TO:	Auckland Council	Date:	5 August 2025
COPY TO:	Euan Williams, Woods Rachel Morgan, Barkers	Document No:	10015-045-1
FROM:	Mark Delaney, Lead Ecologist

MILLDALE STAGES 10-13 FAST TRACK – REQUEST FOR FURTHER INFORMATION – ECOLOGY RESPONSE

MAP NO. 10015.A.1

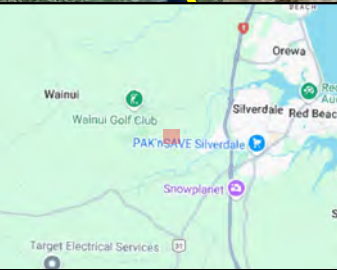
I, Antoinette Bootsma highlight two significant matters: which preclude my support for this application

- *The wetland delineation is based on two disjunct sets of data that cannot be correlated and therefore does not follow the requirements for wetland delineations as specified in the MfE Wetland Delineation Protocols, and*
- *The assessment presenting the proposed offset of a new wetland to account for the permanent loss of wetlands resulting from this application, does not provide supporting hydrological data from which to confirm that a new wetland will be able to be achieved in perpetuity as required in Principle 6 of Appendix 6 of the NPS-FM.*

Integrated wetland plans were provided to Ms. Bootsma, the Auckland Council freshwater ecology technical specialist, on 6 June 2025. These plans have been attached this memorandum for reference. While the plan was considered sufficient, further clarification was requested during a meeting on the 27 June 2025 regarding the absence of vegetation assessments in some areas where soils and hydrology had been assessed (i.e., the perceived lack of correlation between two disjunct sets of data).

These areas lacked obvious wetland hydrology, and the soils, often compacted or modified, were difficult to classify as hydric (see "Difficult Soils" in Section 5.3.2 of the EclA (Viridis 2025a)). Such areas of creeping bent or toad rush dominance were patchy and formed a mosaic across the site, thus were near impossible to map/delineate. Due to the dominance of misleading vegetation and their patchy distribution, it was considered prudent to request that the applicant's hydrology specialist, Williamson Water & Land Advisory (WWLA), to undertake representative soil and hydrology assessments across the site.

No distinct, small-scale locations were identified for targeted hydrology and soil assessments due to the patchy and transitional nature of the creeping bent or toad rush dominant vegetation. Instead, a broader approach was taken where WWLA carried out soil and hydrology testing across representative parts of the site to gain an understanding of the general hydrology and soils in these areas. This explains the presence of sampling points where no specific vegetation assessments were undertaken. It should be noted that WWLA also completed assessments in areas where Viridis identified wetlands to help confirm boundaries.
